Solicitation

NUMBER
7013EC07

LINE	QUANTITY	UOP	CAT NO	ITEM NUMBER	UNIT PRICE	AMOUNT
0001	1	EA		765-64	\$10,068.00	\$10,068.00
NINE CUBIC YARD STAINLESS STEEL REQUEST FOR QUOTATION OPEN-END CONTRACT THE WEST VIRGINIA STATE PURCHASING DIVISION FOR THE AGENCY, THE WEST VIRGINIA DIVISION OF HIGHWAYS, IS SOLICITING BIDS TO PROVIDE THE AGENCY WITH AN OPEN-END CONTRACT FOR NINE CUBIC YARD STAINLESS STEEL DEMOUNTABLE AND ABRASIVE CHEMICAL SPREADERS (HYDRAULIC) PER THE ATTACHED SPECIFICATIONS.						
***** THIS IS THE END OF RFQ 7013EC07 ***** TOTAL:						\$10,068.00
05/13/13 09:14:49 AM West Virginia Purchasing Division

LINE	QUANTITY	UOP	CAT. NO.	ITEM NUMBER	UNIT PRICE	AMOUNT
0001	1	EA		765-64		
ADDENDUM NO. 04 ISSUED TO EXTEND THE BID OPENING DATE FROM 04/24/13 AT 1:30 P.M. TO 05/08/13 AT 1:30 P.M. & TO DISTRIBUTE VENDOR QUESTIONS AND AGENCY RESPONSES.						
***** THIS IS THE END OF RFQ 7013EC07 ***** TOTAL:

Exhibit C

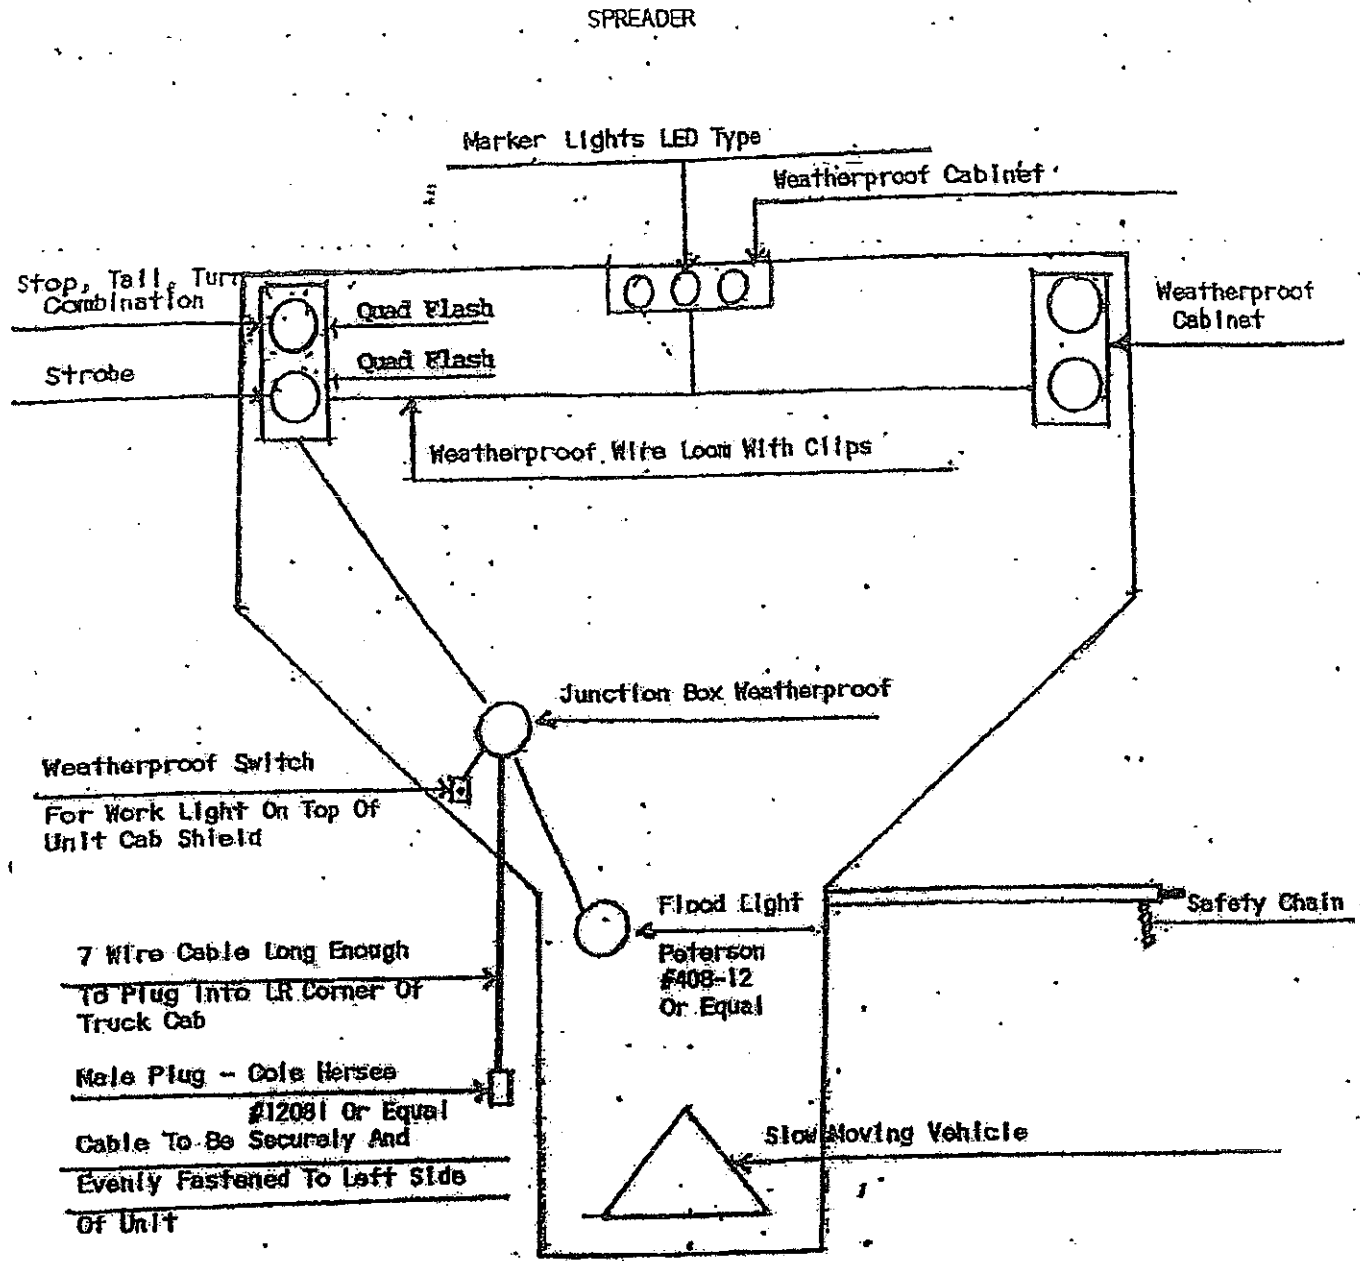
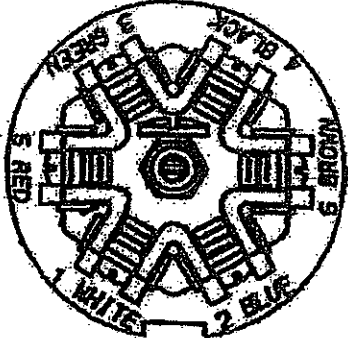
24. **Question:** Baker Equipment: In a previous spec there was a schematic provided and referred to. This is not in the new specification?

Answer: This was distributed at the pre-bid and is also included in this addendum as Exhibit C.
